NAME	EFD-4651 CAP	MATERIAL	PET-FR530	SCALE	1:1	ANGLE	±1°
DRAWING NO.	HX 4601B	PIN MATERIAL		UNIT	m/m	REV.	01
TOLERANCE OF PIN DIA ±0.05		PIN TENSION LOAD		kg/MIN	UL REC.: 94Y0		
TOLERANCE:							
DRAWN & CHECKED BY		LIN HUA JING		CHECKED & APPROVED BY		LIN GUO PING	
DATE:		JUN 14 2010

东莞市华欣塑胶制品有限公司
 DONGGUAN HUAXIN PLASTIC MANUFACTURING PRODUCTS CO., LTD.
 TEL: 0769-86388188 FAX: 0769-86388111
 E-Mail: hxbobbin@vip.163.com

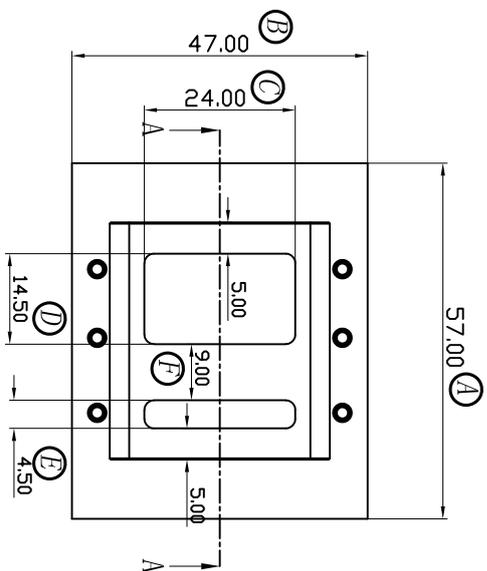
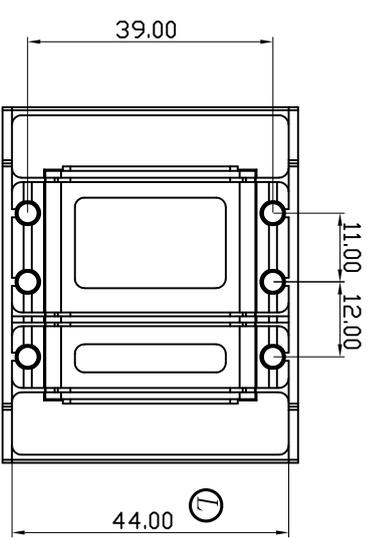
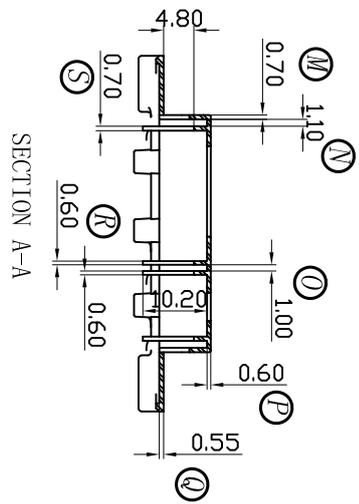
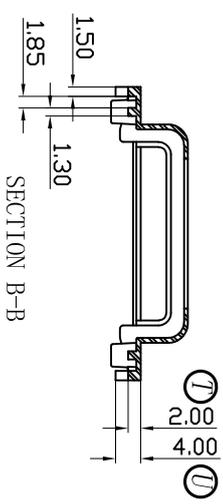
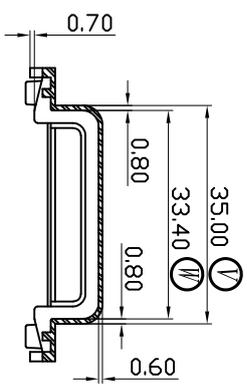
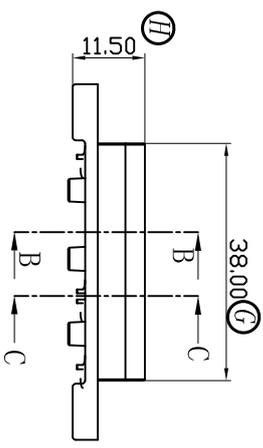
记号	日期	修改记录
1	2010/06/11	1. K尺寸由12.70mm改为12.20mm, 凸点改矮 0.50mm, Q尺寸由0.70mm改为0.55mm
